HISTORIC LANDMARK COMMISSION STAFF REPORT

200 Apartments- New Construction
Case PLNHLC2013-00239
and PLNHLC2013-00240
206 North 200 West
July 18, 2013

Applicant:
Matt Musgrave

CONCEPTUAL SITE PLAN
NEW 200 APARTMENTS FOR MATT MUSGRAVE
206 NORTH 200 WEST
SALT LAKE CITY, UTAH 84103

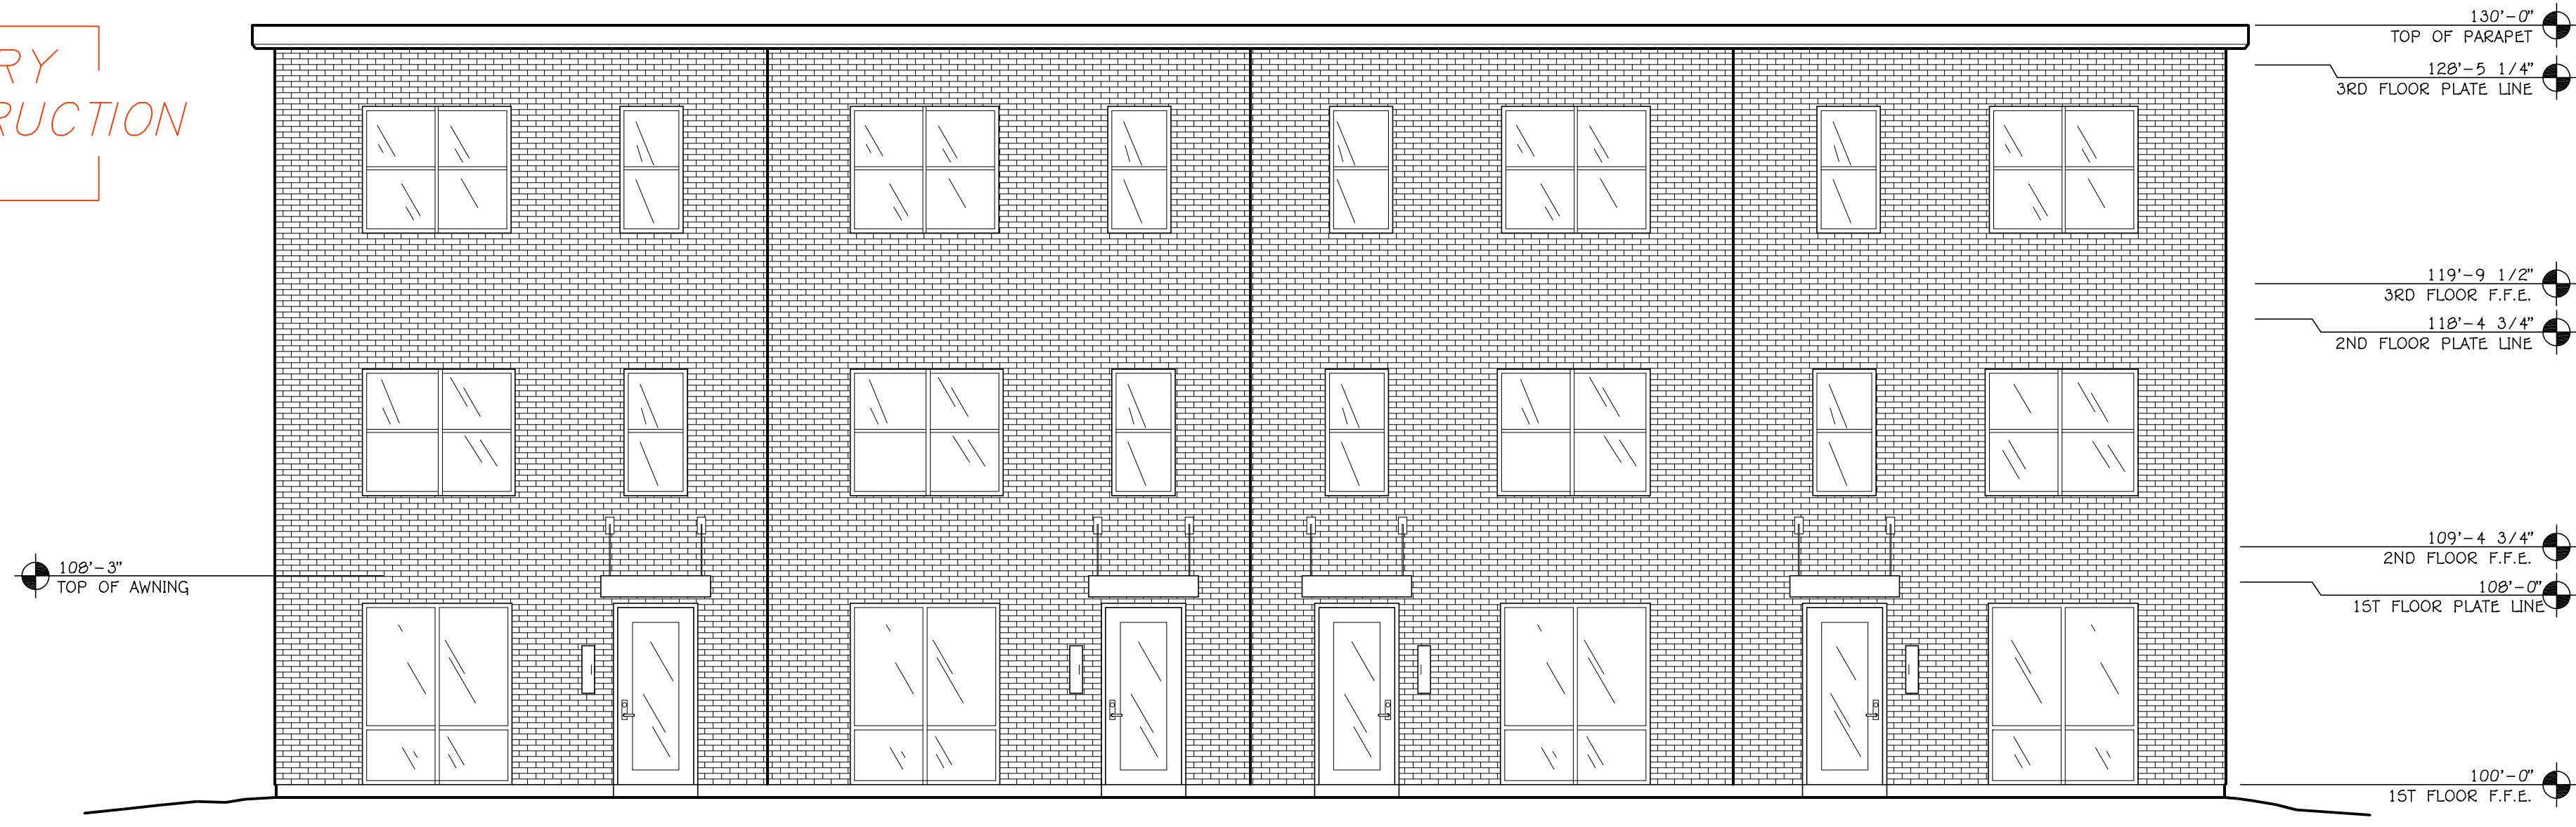
The petitioner addressed each of these concerns in the new design with the exception of rotating the building 90 degrees. The reason this was not done is that in order to achieve a similar design to what is proposed, it would require an encroachment into the front setback. This would have a significant impact on the historic home to the north.

Access to each building would come from 200 West, with a shared driveway between the buildings leading to an individual two car garage for each unit (all required parking will be within the garages). The garages are proposed on the interior and would face each other.

ELEVATIONS - BUILDING A
NEW 200 APARTMENTS FOR MATT MUSGRAVE
206 NORTH 200 WEST
SALT LAKE CITY, UTAH 84103

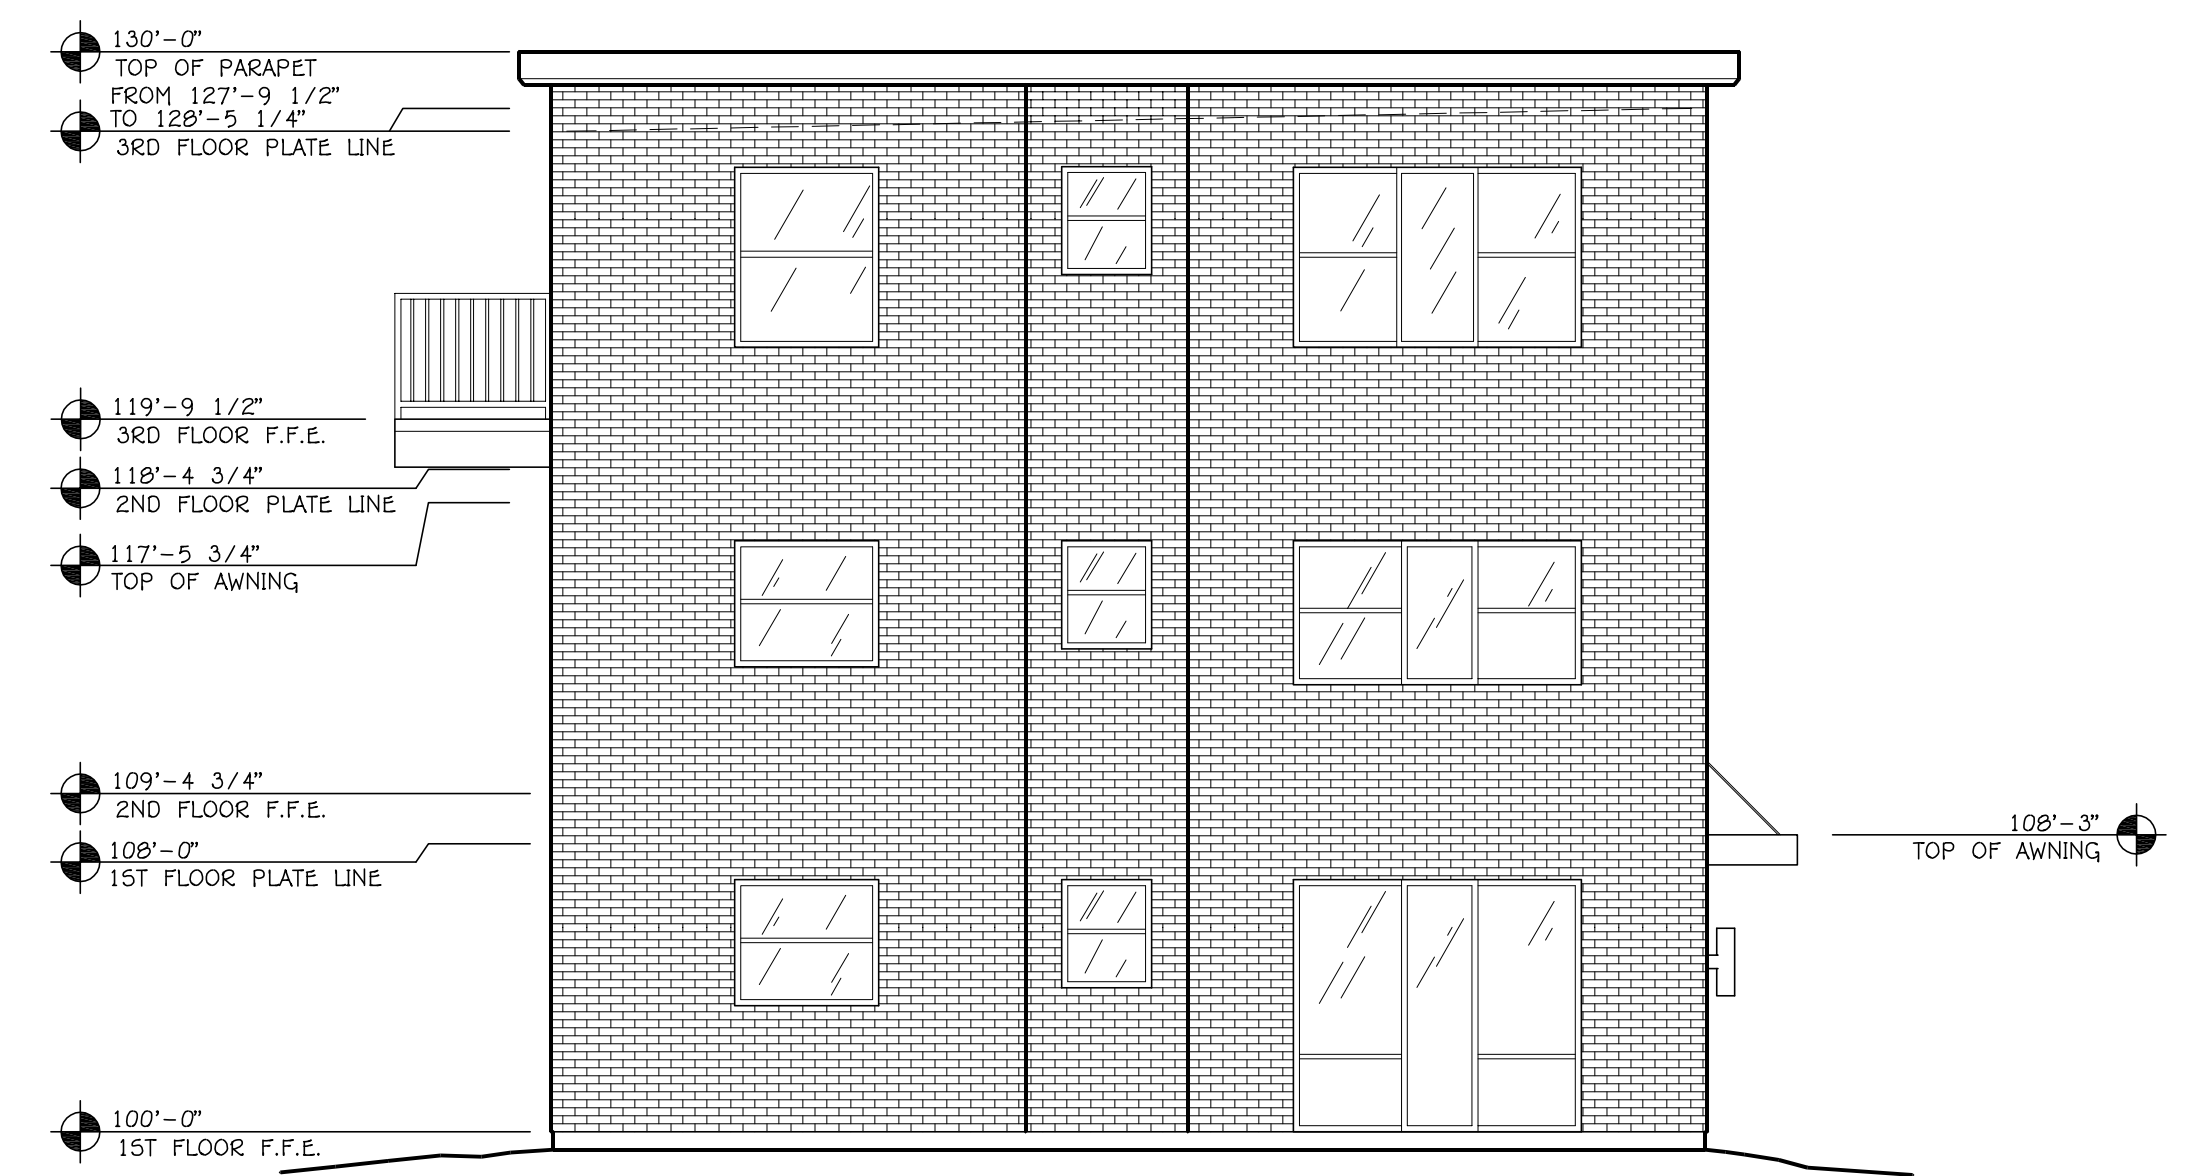
Analysis: The subcommittee requested that the petitioner make the windows less commercial in design, and that they be placed in a more uniform manner on the building. The applicant did so by standardizing the window styles and stacking them one above the other on each floor. Additionally, the design of the windows was changed from aluminum commercial style to a more residential style with double hung and casement type windows proposed. The proposed proportion of openings and rhythm of solids to voids is compatible with apartment buildings seen throughout the Capitol Hill Historic District.

The single family homes on the block face have front pedestrian entrances that are more prominent than the proposal, where as the apartment buildings have little to no entry features. The proposed buildings have the primary entrances facing 200 North and 200 West with a metal awning proposed over each entry. These entries are similar in style and design to other multi-family structures in the area. The relationship of materials in the proposal, primarily brick, will be visually compatible with other structures on the block face. The most prominent building material on the block is brick with various material types as accents.
